DAN930 Alternator

New production site

The DENSO Aftermarket catalogue part no remains the same, DAN930, whereas the DENSO Aftermarket technical code is substituted from 104210-2710 to 021080-2590.

Rear view

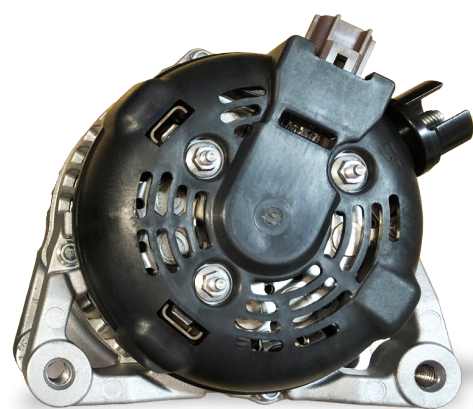
Lead frame new design without the 3 drain holes vs outside, internal labyrinth avoid direct contamination (no impact on cooling)

Lead frame old design with 3 drain holes vs outside through rear cover

Front view

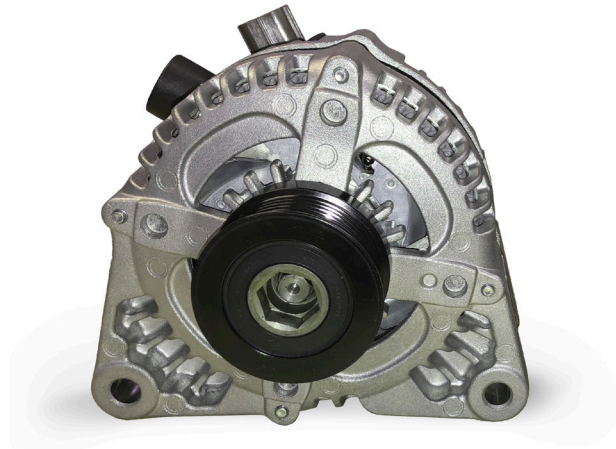
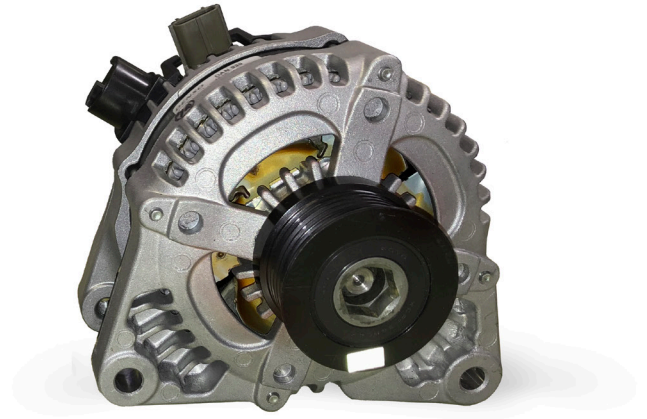
Rotor impregnation resin can be visible on fan randomly.
(No impact for durability or contamination)
